## REMARKS

Amendments to the Drawings:

*FIG. 6*

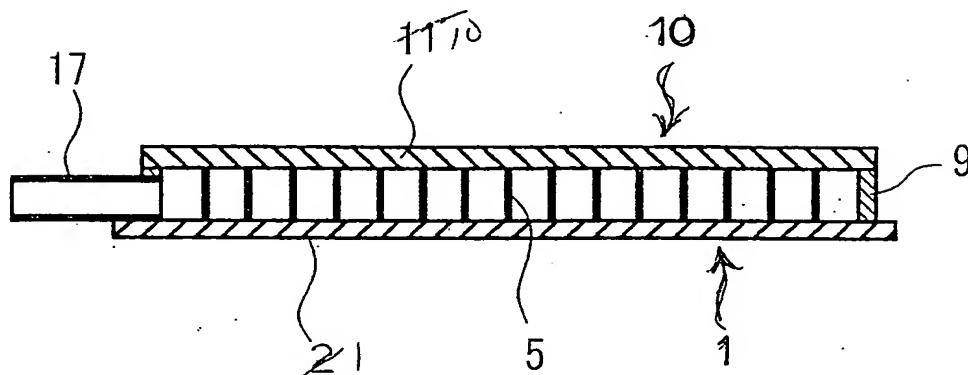
With regard to the objection to the drawings, Fig. 20 has been amended to show that reference character 8 is directed to a different structural element than reference character 6 and, further, Fig. 6 has been amended to correct reference character designations therein, with replacement sheets for Figs. 20 and 6 being presented. More particularly, Fig. 20 has been amended to show in cross-section that the branch line 8 is a separate structure from that of the control electrode line 6, and Fig. 6 has been amended to more properly show glass substrates 2 and 11 of the electron beam source panel 1 and the phosphor screen panel 10, respectively. Thus, Fig. 6, as amended, clearly shows the feature that the partition walls 5 each have one end in contact with a second panel-side surface 2 of the control electrode 7, noting that the control electrode 7 is provided on the substrate 2. As such, applicants submit that the drawing objections should now be overcome.

The attached sheets of drawings include changes to Figs. 6 and 20. These sheets, which includes Figs. 6-7 and Figs. 18-20, replace the original sheets including Figs. 6-7 and Figs. 18-20. Fig. 20 has been amended to show that reference character 8 is directed to a different structural element and Fig. 6 has been amended to correct reference characters.
